# REGULATORY INFORMATION DISTRIBUTION SYSTEM (RIDS)

SUBJECT: Responds to request & commitments made during 851008 meeting  
 & in 850918 ltr re auxiliary pressurizer spray sys.  
 Implementation of listed enhancements scheduled for first  
 refueling outage for Unit 1. Concurrence requested by 851022.

ANPP-33713-WFQ/TFQ  
October 15, 1985

Subject: Palo Verde Nuclear Generating Station (PVNGS)  
Units 1, 2 and 3  
Docket Nos. STN-50-528 (License No. NPF-41)/529/530  
Auxiliary Pressurizer Spray Design  
File: 85-056-026; G.1.01.10

FIGURE 1

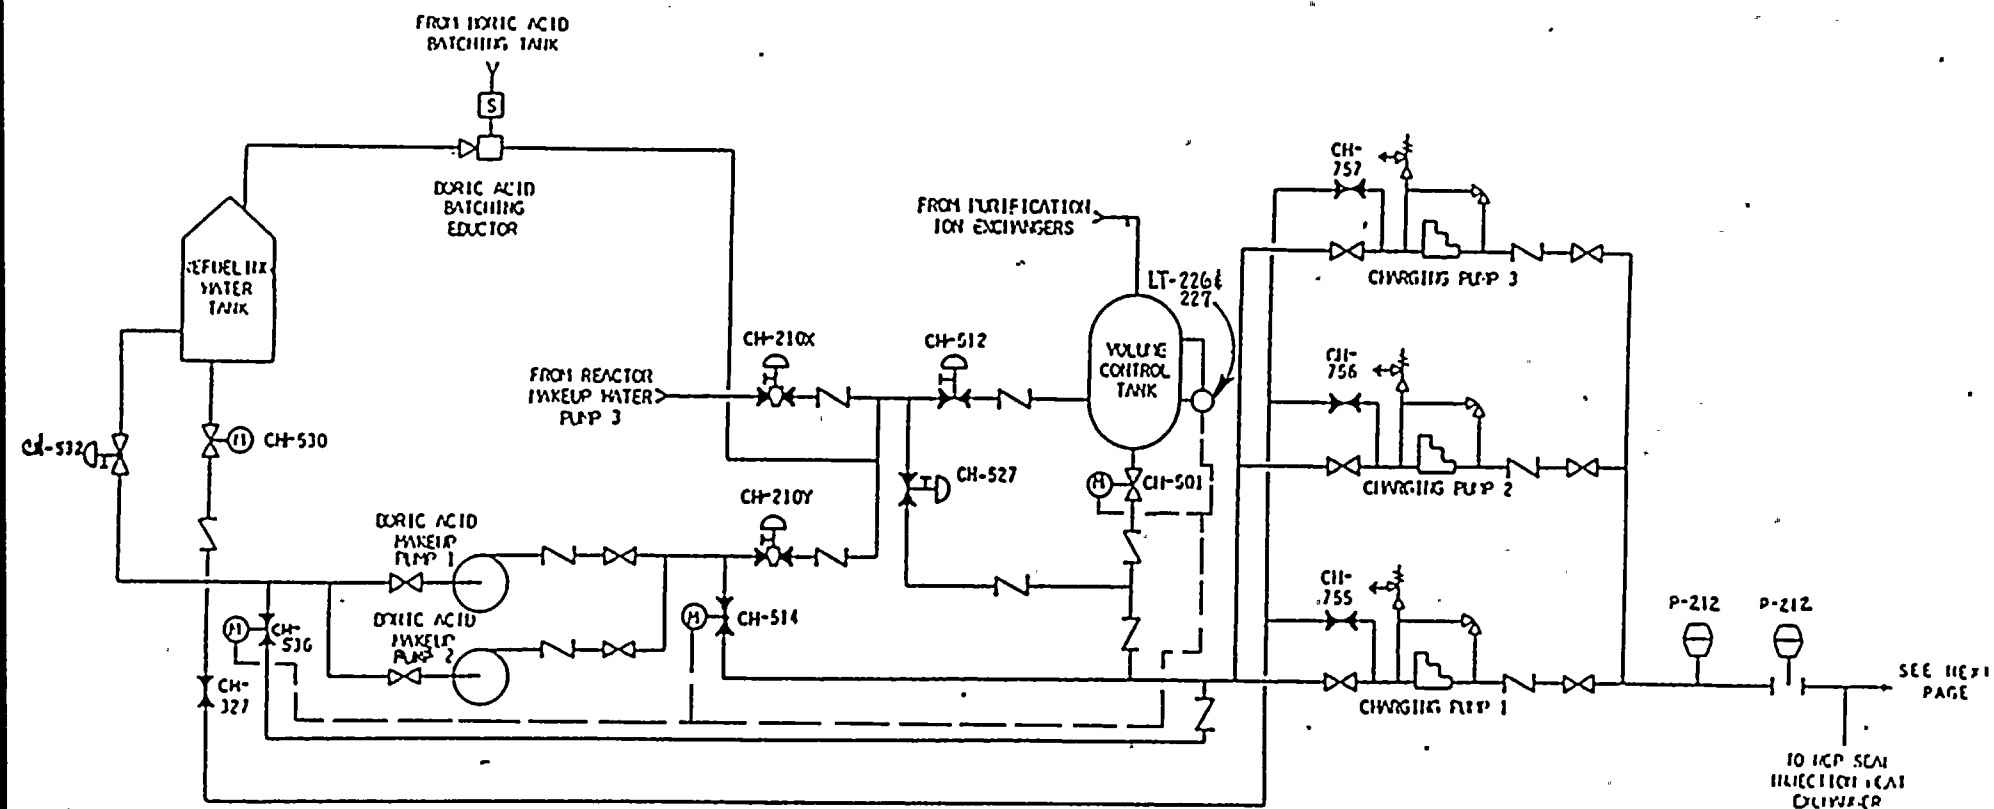
recover from this condition would require closing the manual isolation valves on the individual charging pump suction lines (see Figure 1 of this Attachment 3) thereby isolating the VCT from the charging pumps, venting off the short section of piping between the isolation valves and the charging pumps, and aligning an alternate gravity feed line from the Refueling Water Tank (RWT) by opening manual valves CH-327 and CH-755 through -757. This action can be taken and the system restored to operable status within the two hour time requirement established in the revised Steam Generator Tube Rupture analysis. However, to minimize operator actions, enhancements in the reliability of the Volume Control Tank (VCT) level instrumentation, the power supply to valves CH-501 (VCT outlet valve) and CH-536 (RWT gravity feed line), and in the provision for automatic realignment of the charging pumps to alternate suction sources will be made to reduce the potential for gas binding the charging pumps, provide a large reduction in the potential for loss of auxiliary pressurizer spray and charging capability and result in system capabilities commensurate with the system usage.

FIGURE 2

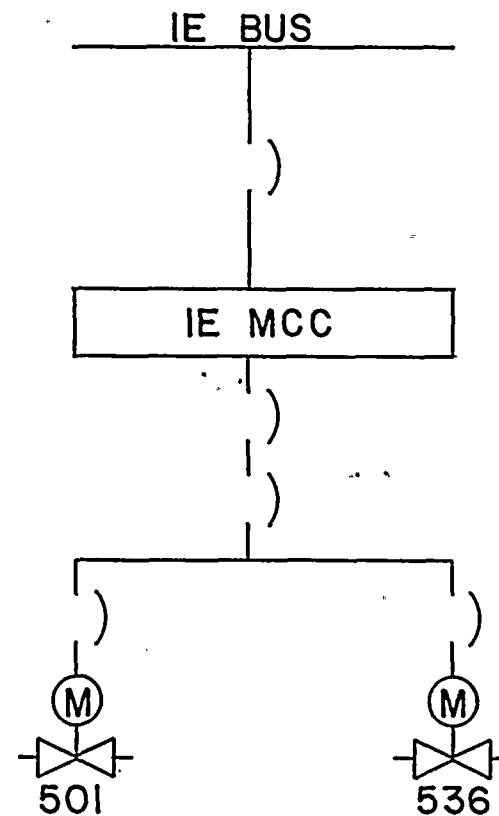
To eliminate the need for the operator to manually align the suction of the charging pumps to the RWT, the existing automatic transfer on lo-lo VCT level indication feature will be enhanced. With the existing design, a lo-lo VCT level indication causes the automatic realignment of the charging pumps to the Boric Acid Make-up Pump flow path by opening valve CH-514 and closing valve CH-501. A design modification will be implemented to allow automatic realignment to the RWT gravity feed line via valve CH-536 on lo-lo VCT level when the non-class IE powered Boric Acid Make-up Pump flow path is unavailable due to loss of off-site power. This will be accomplished by instrumentation sensing a loss of power to valve CH-514 and causing valve CH-536 to open then on lo-lo VCT level signal. Thus, alignment of the charging pumps will be selectively made to either of two flow paths from the RWT depending on whether off-site power is available. This modification will accomplish design objective number 2.

FIGURE 3

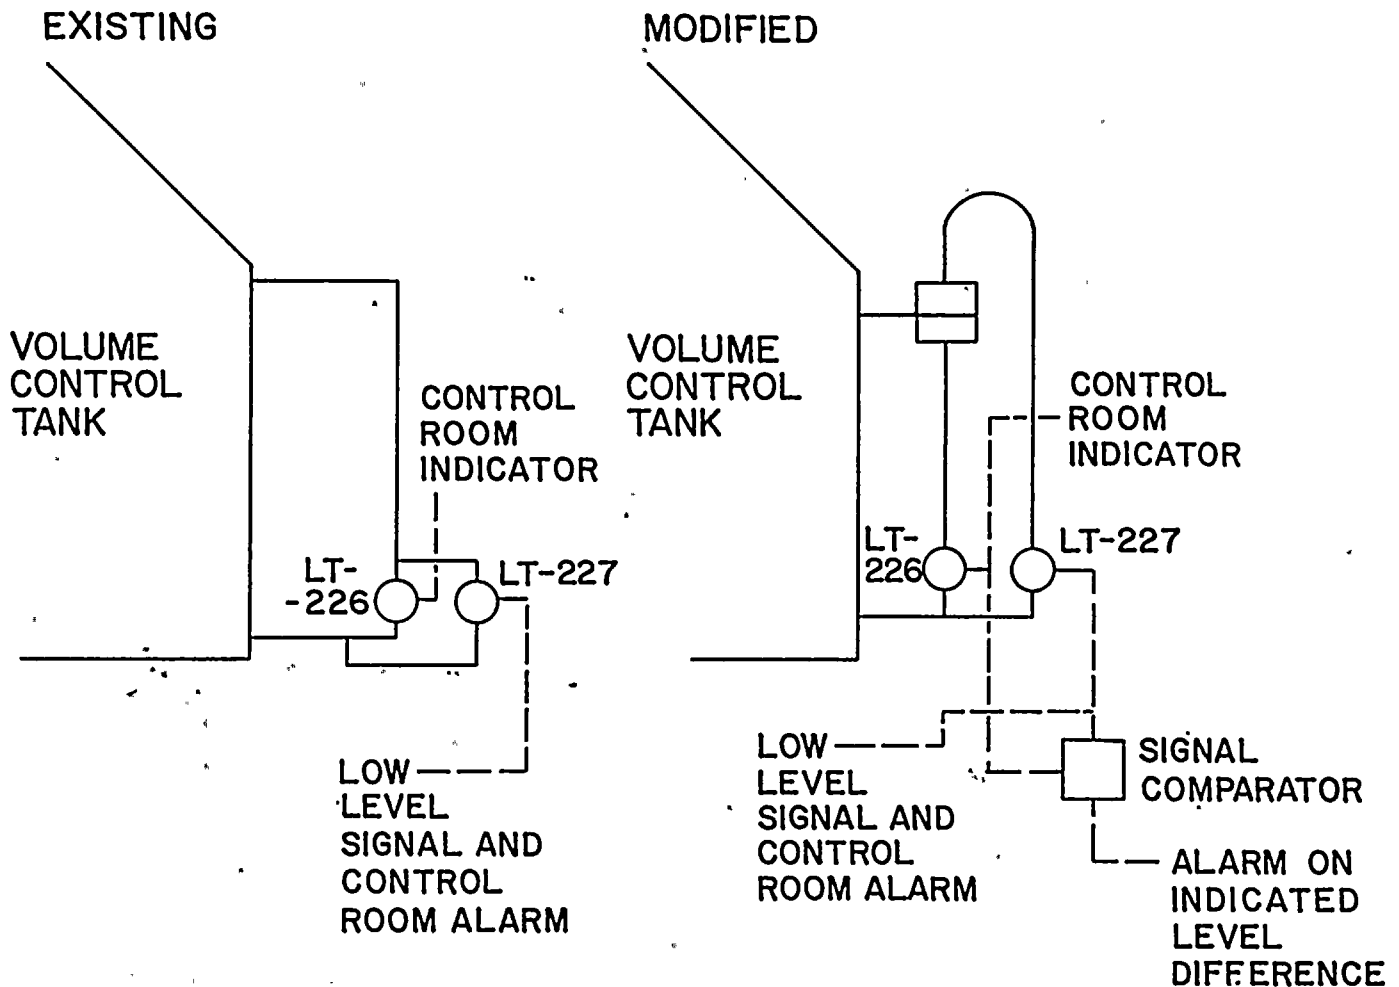
# VALVE POWER SUPPLY CHANGE

EXISTING

MODIFIED

these valves will be modified to provide power from Class IE Motor Control Center (MCC) M-35. The cable used to connect these valves to the Class IE MCC does not meet Class IE standards, therefore, an appropriate isolation device consisting of two Class IE breakers in series will be provided to meet the requirements of IEEE 279 (see Figure 3). The MCC M-35 that will supply valves CH-501 and CH-536 is not automatically shed from the Class IE bus on a Safety Injection Actuation Signal (SIAS) and is automatically sequenced on to the Emergency Train A Bus following a Loss of Off-site Power (LOP). Therefore, this design change accomplishes design objective number 1.

CHANGE ENSURES OPERABILITY FROM CONTROL ROOM AFTER SIAS AND LOP SUCH THAT SUCTION COULD BE ALIGNED TO RWT FROM VCT.
